STAFF REPORT AND RECOMMENDATION TO THE DESIGN COMMISSION

CASE FILE: LU 14-246259 DZM
PC # 14-184664
Couch 9
REVIEW BY: Design Commission
WHEN: March 19, 2015 @ 1:30 PM
WHERE: 1900 SW Fourth Ave., Room 2500A
Portland, OR 97201

The applicant seeks Design Review approval for a mixed-use building at the northwest corner of NW 9th Avenue and Couch Street in the River sub district of the Central City plan district. The 11-story building would contain commercial uses on the ground level (approximately 8,000 SF) with 137 residential units on the upper floors. Two underground levels of parking would be provided with 87 spaces accessed at the north end of the site off NW 9th. A loading bay is proposed adjacent to the garage entry to accommodate one of the two small loading spaces provided on site. Bike parking for the building's occupants (242 total) would be provided throughout the building in common storage areas and within the individual units. Short-term bike parking for visitors will be placed in the sidewalk along the building's frontage by paying into the PBOT bike fund. A roof garden at the second floor level will provide a storm water retention and filtration area. Amenities for t

C28
 ROOF AXON
VIC

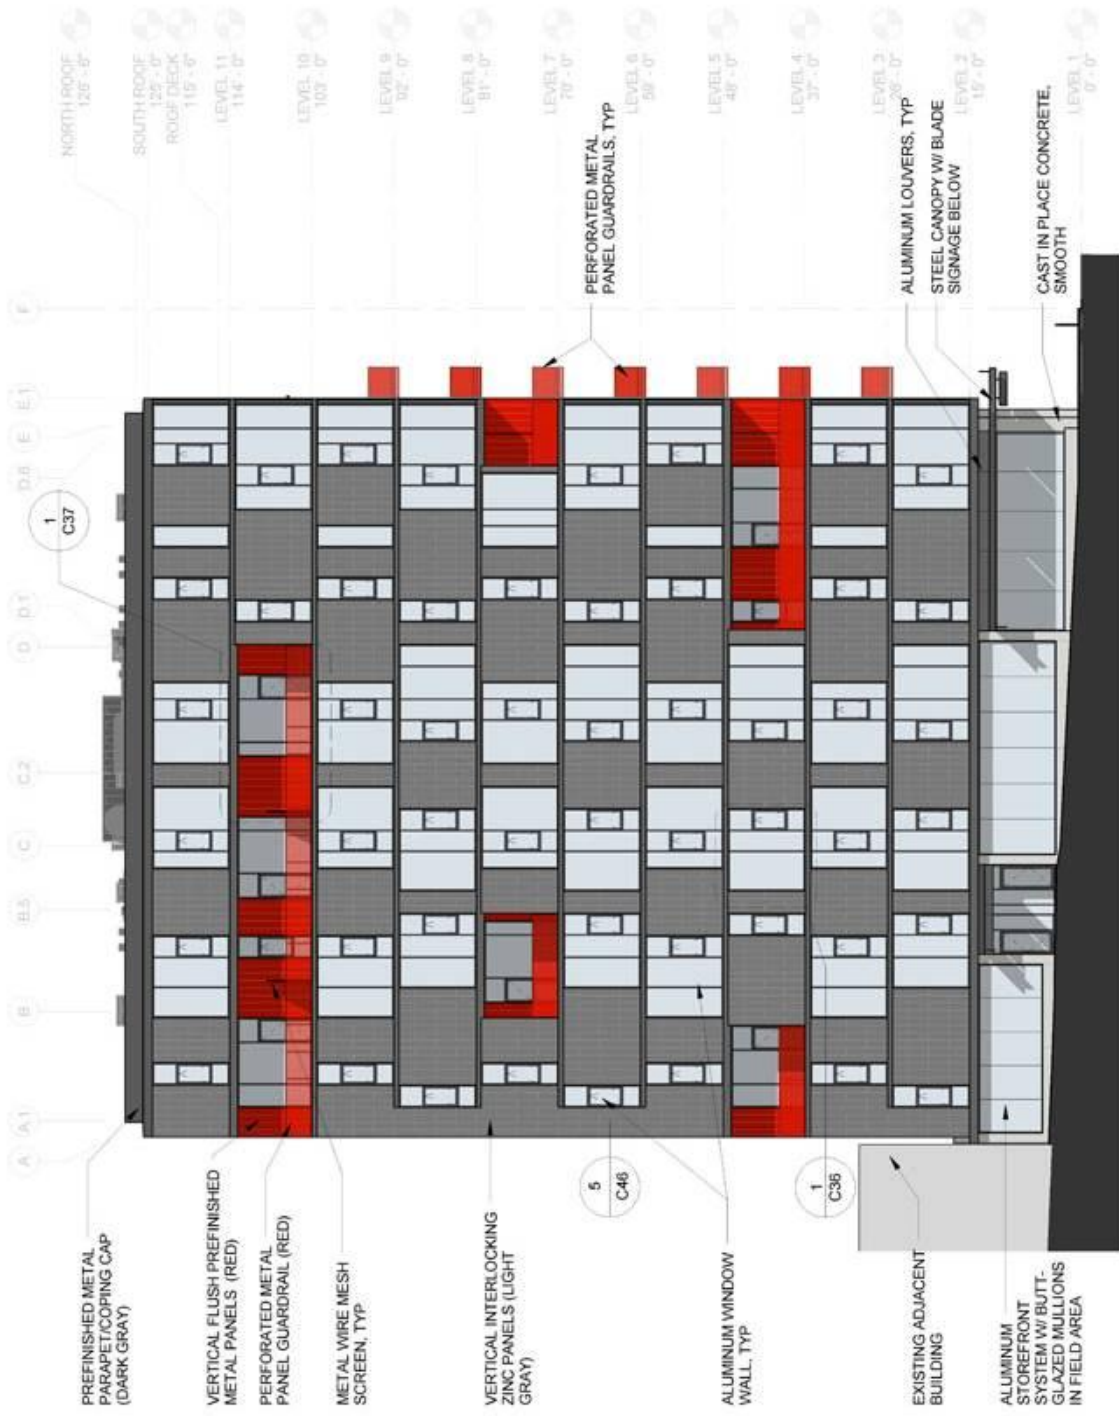
The composition of the rooftop and its components were also discussed at the DAR, although the conversation was limited due to the lack of information and detailing at the conceptual design stage of the DAR. Now more developed, the lower roof on the west end functions as a stormwater facility and visually amenity to the balconies and units above. The upper roof has two levels; the south end, which is the highest, and the north end which steps down to the 10th floor for an outdoor amenity space for the residents. The enclosed portion of the amenity space steps back on the north roof volume, which helps to reduce the mass. Staff feels that this rooftop element could be lighter and more integrated if more glazing were added to the west façade and/or more horizontal elements were introduced, perhaps along the parapet, to help break down the mass of the element. Therefore, Staff recommends a condition of approval to increase the amount of windows by 25% on the west façade with similar proportions as the windows on the east façade of the rooftop enclosure. If the Commission desires alternate conditions could be considered that would achieve similar result.

The upper roofs contain a significant amount of mechanical units. At the DAR the Design Commission stated the rooftop mechanical should be organized and screened. Efforts have been made to do both by grouping the units and increasing the parapets. Staff feels this approach is successful for some of the units on the upper roofs, however, not with the units on the lower northern roof that flank the outdoor terrace and are close to the east roof edge of the building. Relocating these units, using smaller units, enclosing them in a screen would better obscure them from eastern vantage points and allow for a, possibly larger, and more pleasant outdoor space. Therefore, Staff recommends a condition of approval for the mechanical units on the lower northern roof to be less visible by relocating to the western portion of the lower roof, replacing them with smaller units or enclosing them in a screen.

- F. Prior to building permit issuance, the amount of windows on the west façade of the rooftop enclosure on the northern roof shall be increased by 25% and be of similar proportions as the windows on the east façade of the same rooftop enclosure.

- G. Prior to building permit issuance, the mechanical units on the lower northern roof are to be less visible by relocating to them to the western portion of the lower roof, replacing them with smaller units or enclosing them in a screen.

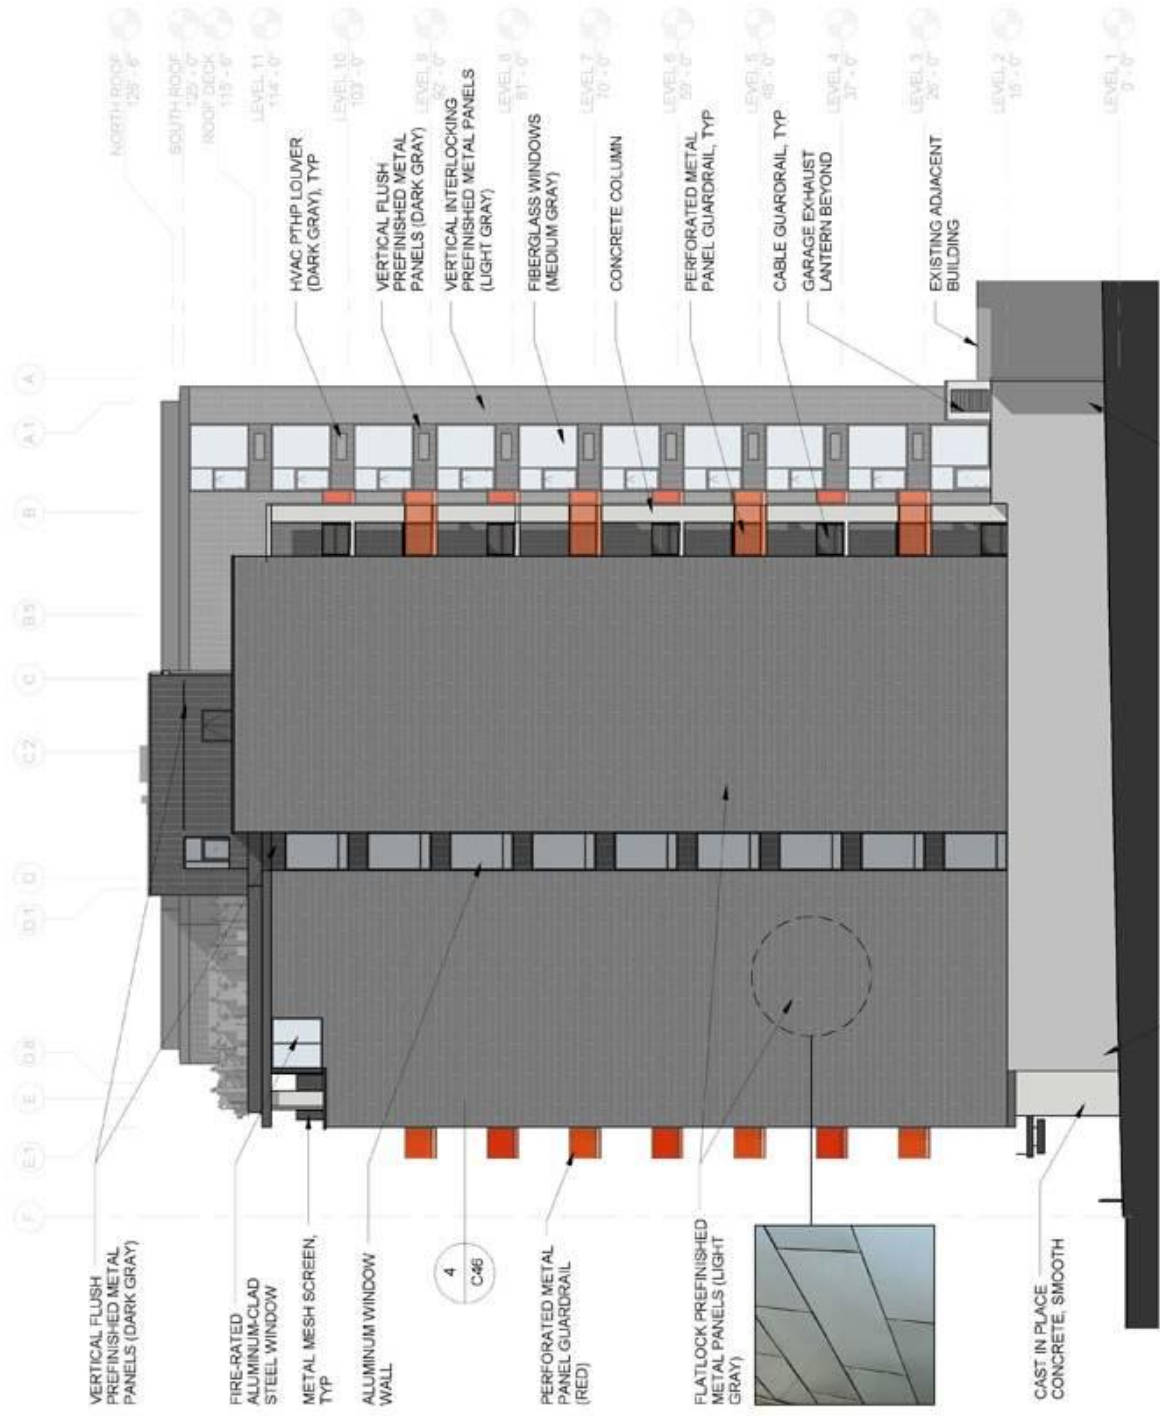
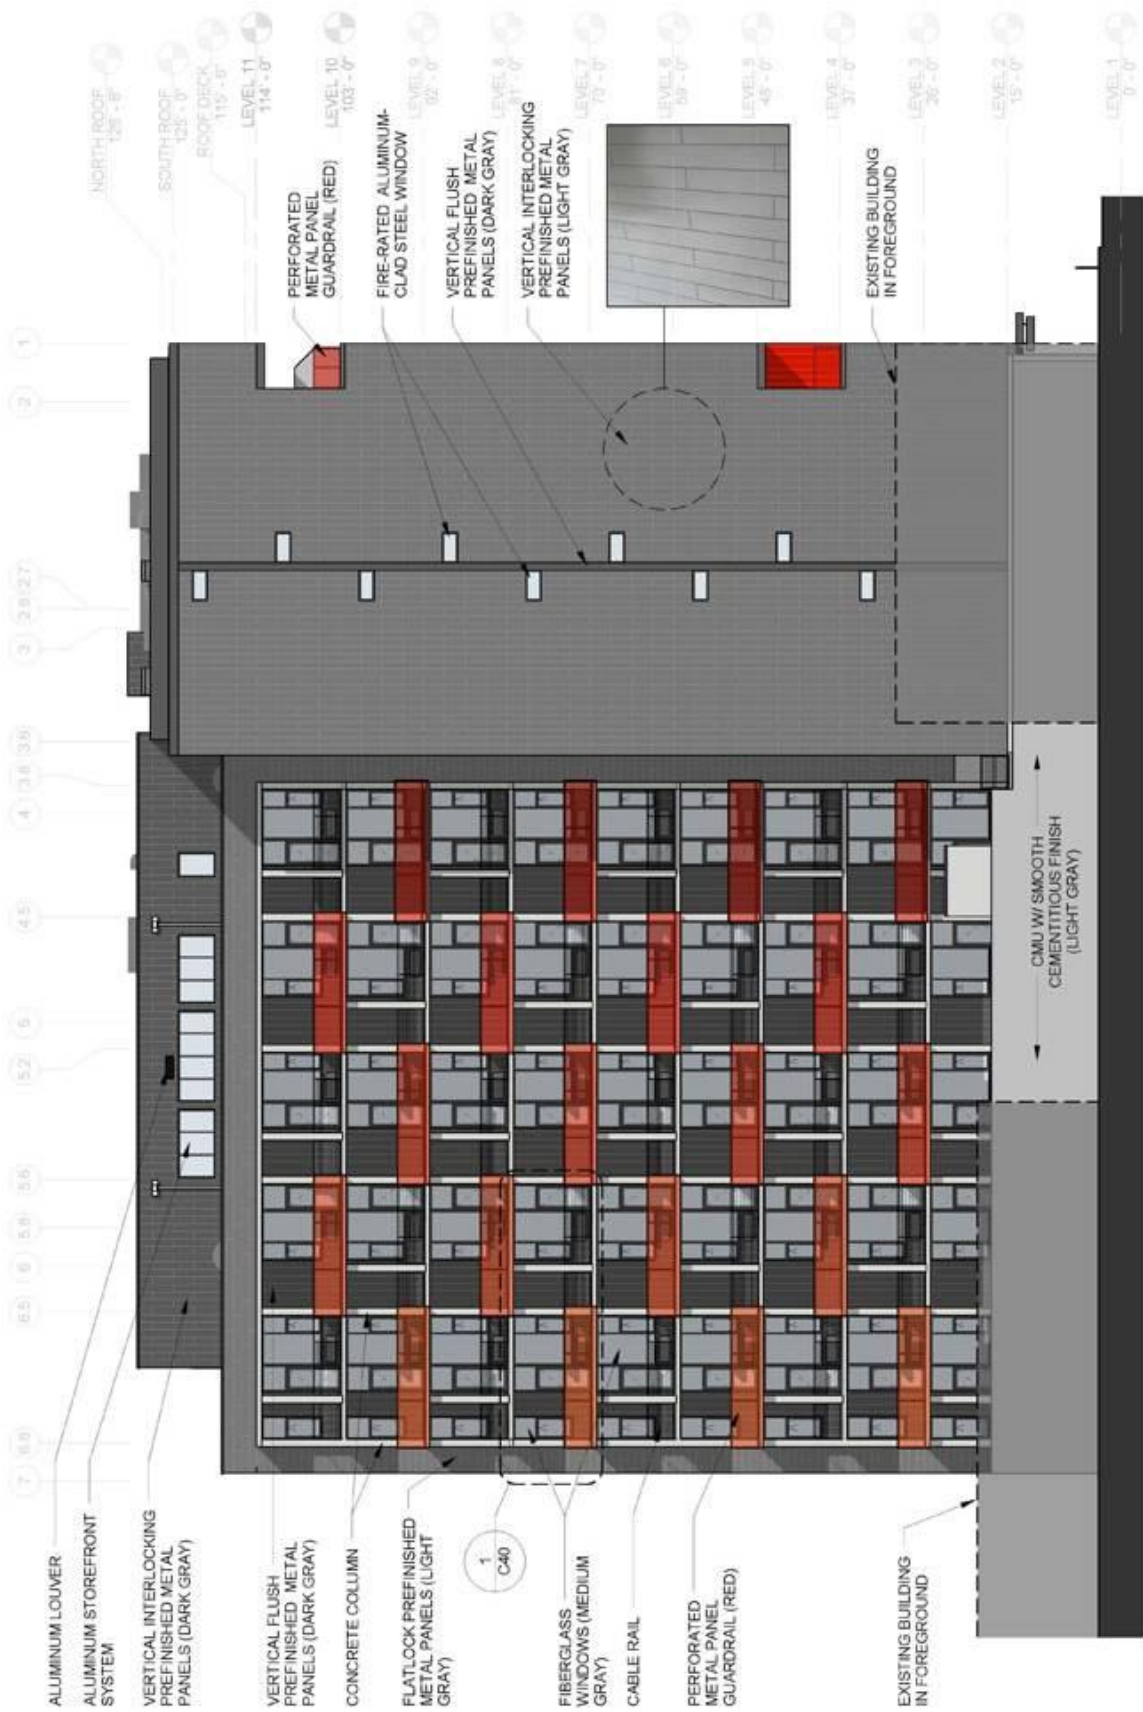
At the DAR the Design Commission highlighted several elements to improve the design, durability and coherency of the vehicle access area, specifically, use durable materials, locate the overhead and garage doors near the building façade and incorporating more glazing and necessary service elements. As noted in the findings above, the Transportation has accepted the garage door location at the building face. Staff has concerns regarding the durability of the 18 gauge metal panel system that surrounds the vehicle entry points and feels that more of the storefront system could be extended in this area to provide some relief from the more solid metal elements in this service area. To address these concerns, Staff recommends the following conditions of approval that will better integrate the parking:

1. The vertical flush metal panels surrounding the garage entry and loading bay on the east facade shall be replaced with either concrete or steel plate of a similar dark color.
2. The solid metal overhead door to the loading bay shall be replaced with a glazed aluminum overhead door (with opaque or clear glass) that matches the finish and color of the storefront system and adjacent egress door.

- C. Prior to building permit issuance, the vertical flush metal panels surrounding the garage entry and loading bay on the east facade shall be replaced with either concrete or steel plate of a similar dark color.

- D. Prior to building permit issuance, the solid metal overhead door to the loading bay shall be replaced with a glazed aluminum overhead door (with opaque or clear glass) that matches the finish and color of the storefront system and adjacent egress door.
